### APPEAL SUMMARY

<b>Appeal ID:</b> 22236	<b>Project Address:</b> 1518, 1520, 1522, 1524 N Blandena St
<b>Hearing Date:</b> 12/18/19	<b>Appellant Name:</b> Paul Wolfe
<b>Case No.:</b> B-014	<b>Appellant Phone:</b> 5039543065
<b>Appeal Type:</b> Building	<b>Plans Examiner/Inspector:</b> Geoffrey Harker
<b>Project Type:</b> commercial	<b>Stories:</b> 4 <b>Occupancy:</b> R-1 <b>Construction Type:</b> V-A
<b>Building/Business Name:</b> Homestead at Pittman Park Hotel	<b>Fire Sprinklers:</b> Yes - Throughout - NFPA 13
<b>Appeal Involves:</b> occ Change from R-2 to R-1	<b>LUR or Permit Application No.:</b> 14-254723-CO
<b>Plan Submitted Option:</b> pdf [File 1]	<b>Proposed use:</b> Transient Dwelling (Hotel/Motel)

**Homestead at Pittman Park Hotel**  
1518 N Blandena Street, Portland, OR 97217

Existing/Proposed Second Floor Plan  
Scale: 3/32" = 1'-0"

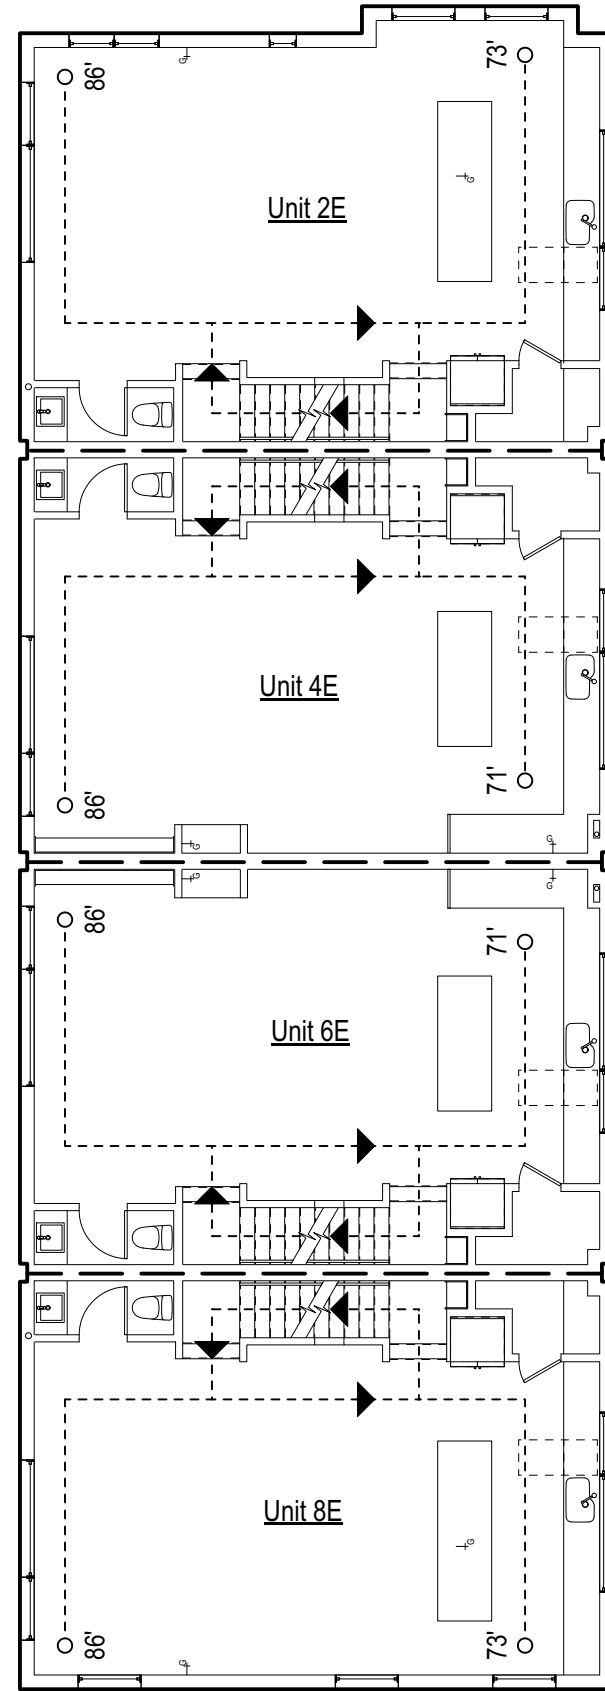
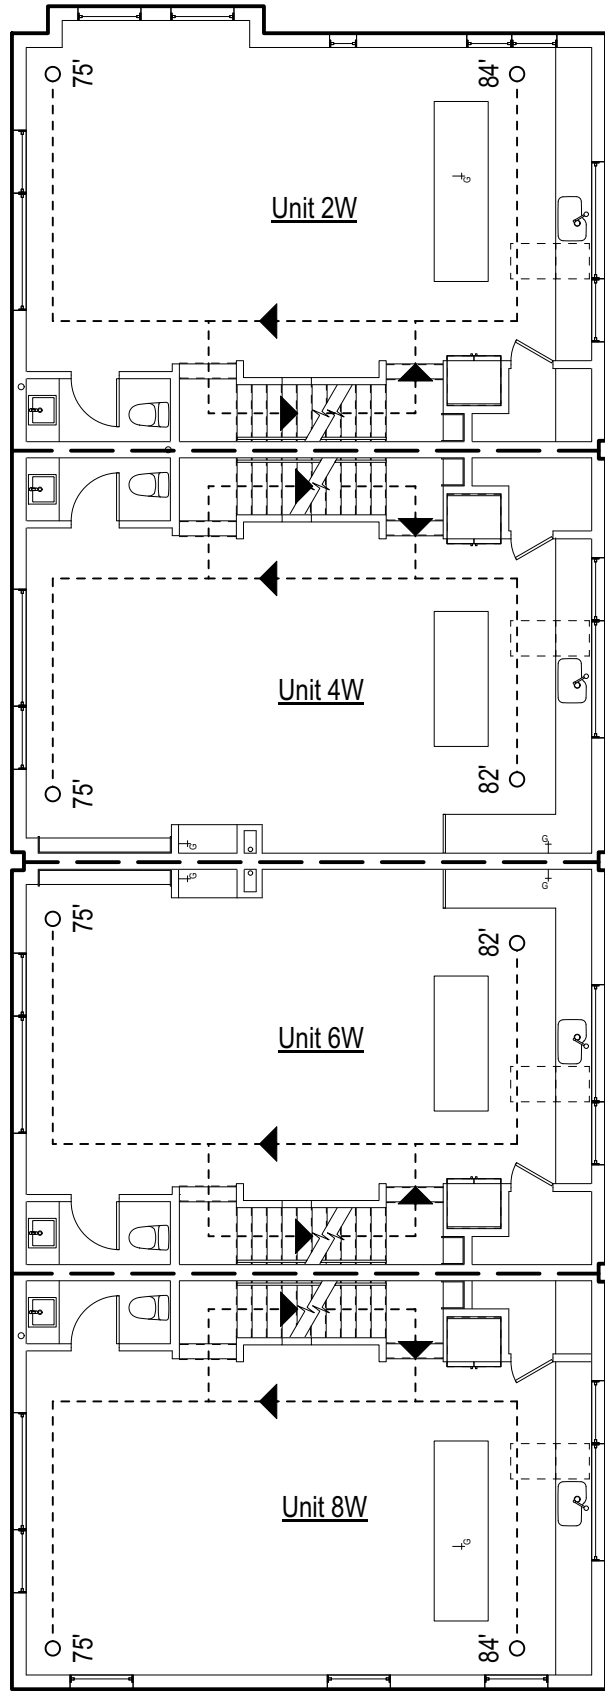
The existing units are 4-story and include one central, open stair connecting all 4 stories. The upper story of each unit includes a living area and exterior roof deck. Maximum travel distance as

existing/proposed is 121' from the most remote point of the roof deck area to the exit on the ground floor. Two exits are provided from each R-1 dwelling unit, at ground level, each exiting to a separate side of the building; one exit to the central shared drive court between buildings and one exiting to a sidewalk between the building and the east or west property line. The buildings are equipped throughout with an NFPA 13 fire sprinkler system. Each 4-story unit is separated by a 2-hr rated fire barrier.

**Reason for alternative** Section 1006.3.3.5 allows for multistory dwelling units to have a single exit access provided those units comply with two criteria. Section 5.2 is for the exit to be at the level of exit discharge and our proposal complies with that criterion. Section 5.1 requires compliance with Table 1006.2.1 Spaces with One Exit. For the reasons outlined below we propose the 4-story R-1 units should be permitted to use the R-2 travel distance of 125' per Table 1006.2.1 rather than the 75' travel distance required for R-1 occupancies.

**Increase in maximum allowable exit access travel distance: Denied. Proposal does not provide equivalent Life Safety protection.**
